Agenda
Village of Arlington Heights
Design Commission
Community Room, 3rd Floor

Arlington Heights Village Hall
33 S. Arlington Heights Road
Arlington Heights, IL 60005
October 24, 2017
6:30 PM

MINUTES OF
THE VILLAGE OF ARLINGTON HEIGHTS
DESIGN COMMISSION MEETING
HELD AT THE ARLINGTON HEIGHTS MUNICIPAL BUILDING
33 S. ARLINGTON HEIGHTS RD.
OCTOBER 10, 2017

3-REAR ELEVATION
3-RIGHT SIDE ELEV.

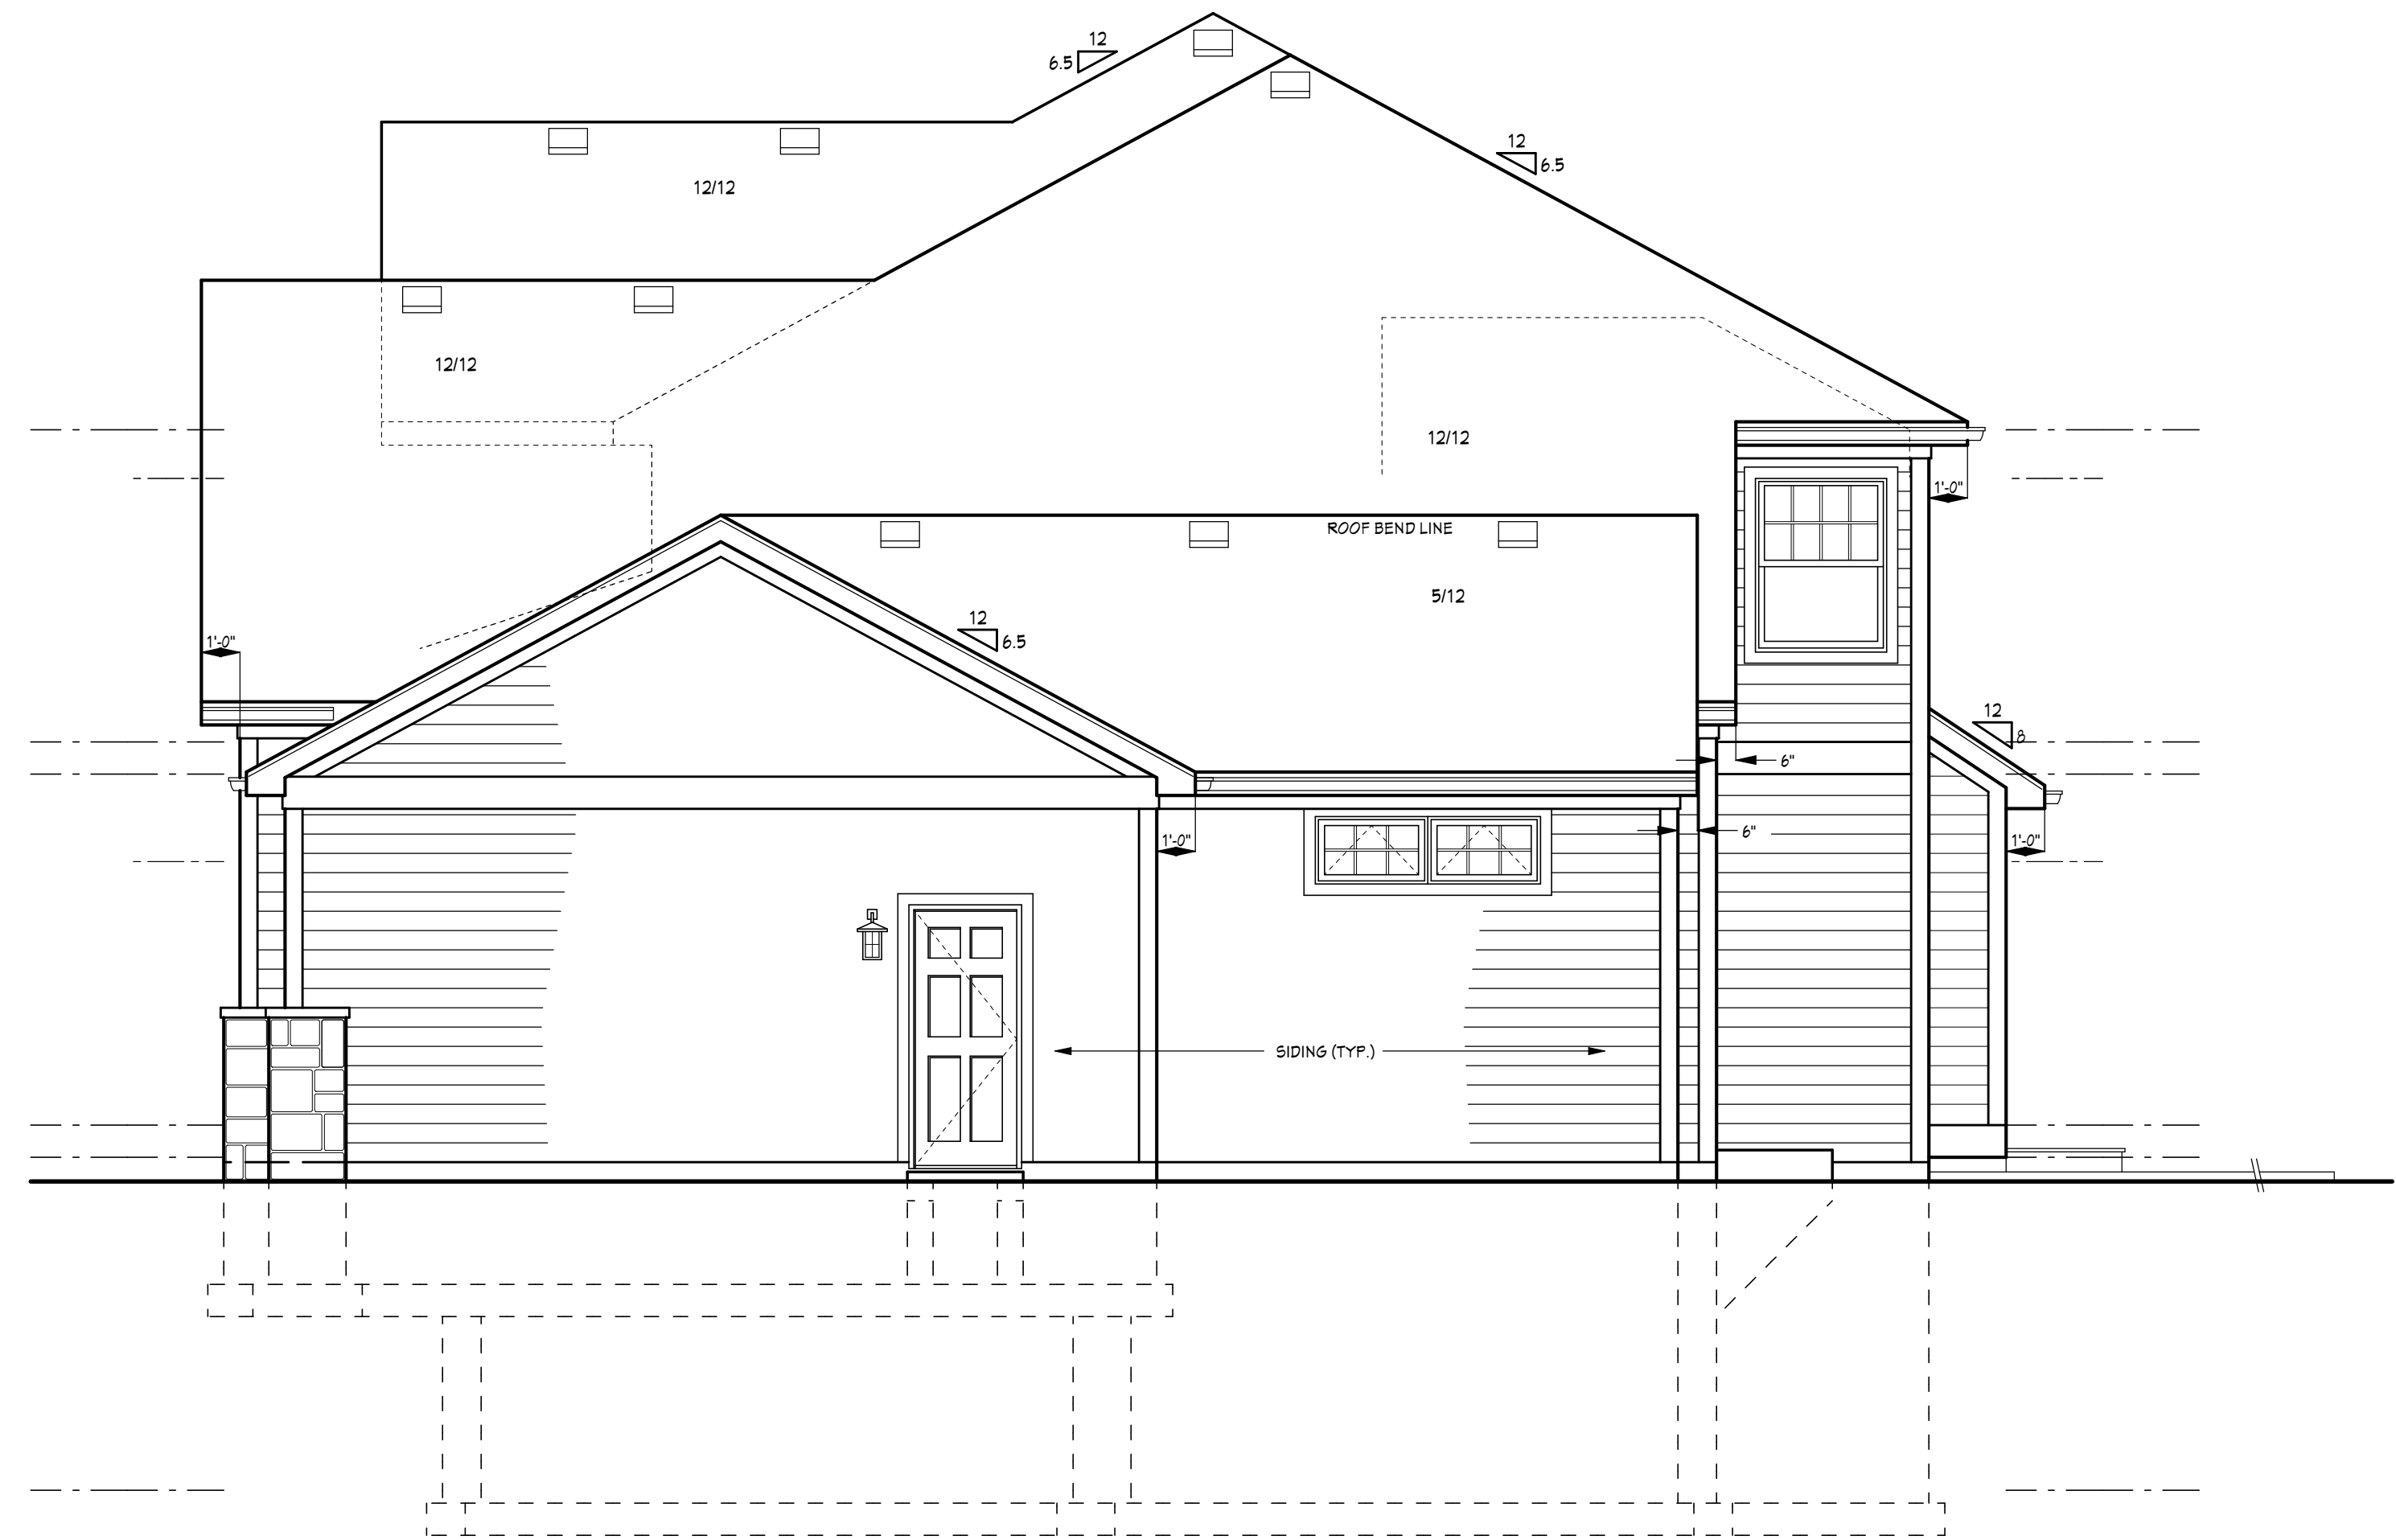
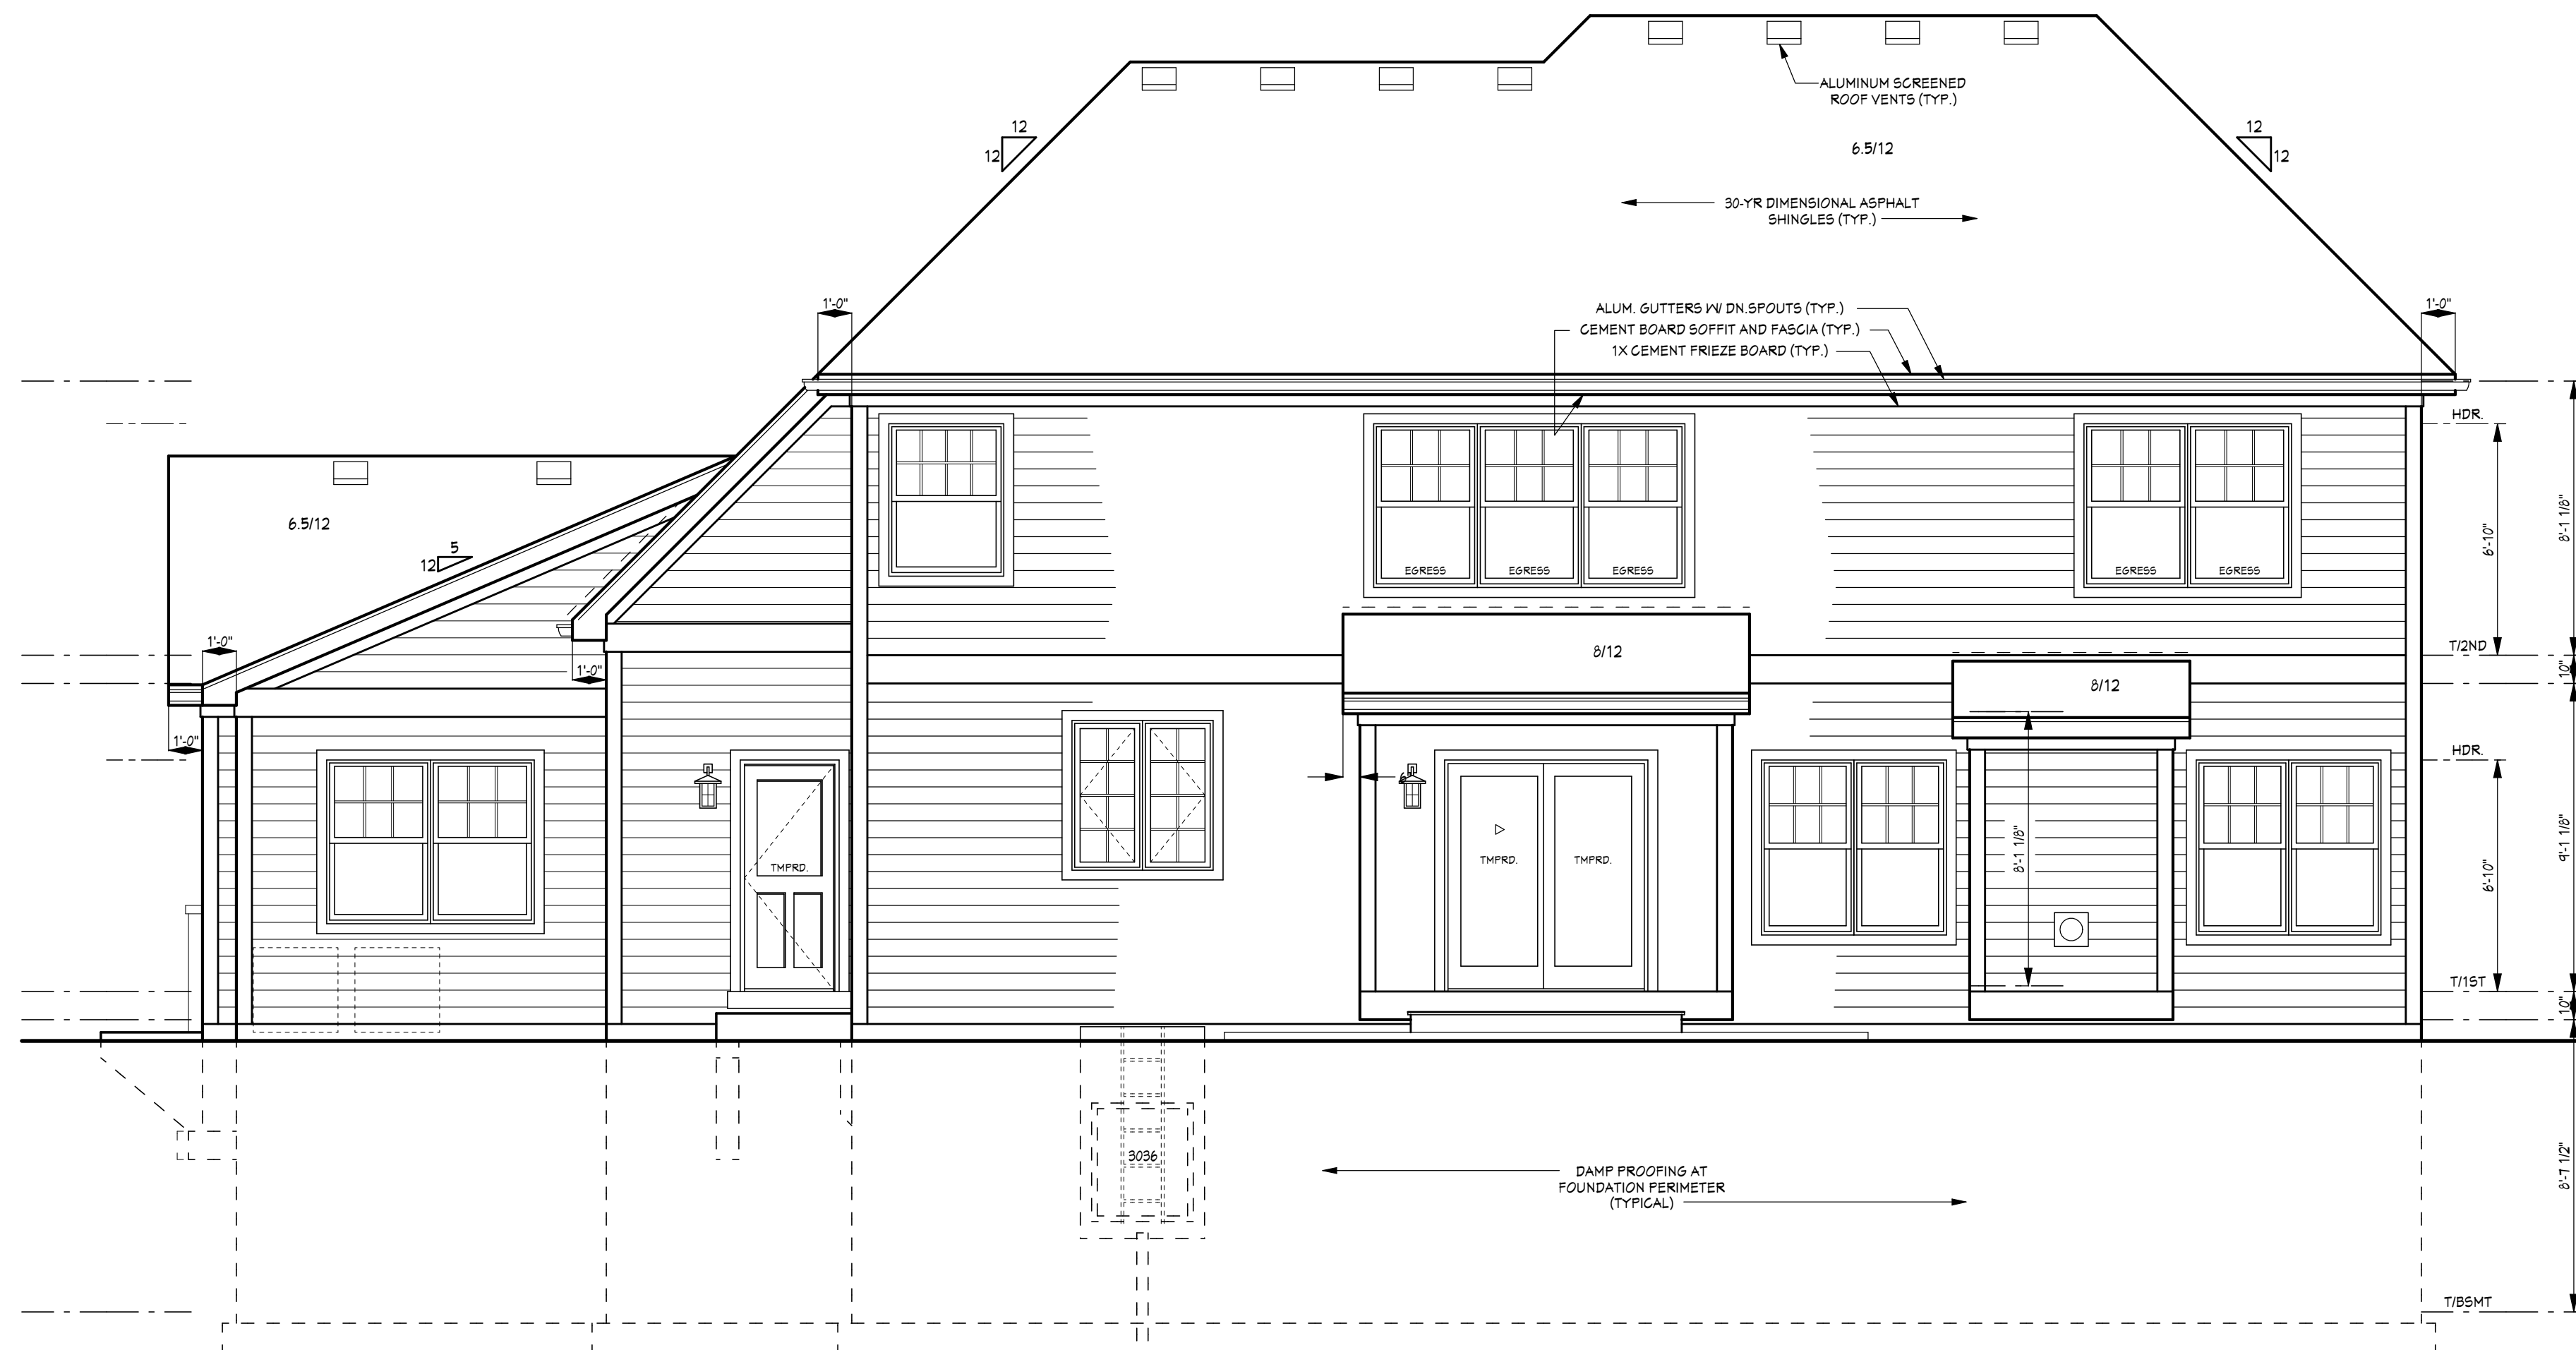
1. Stone Base. The stone base should be continued around all sides of the house, or at least be returned down the sides to a natural break point.
2. Right Elevation. Add one window to the side of the garage.
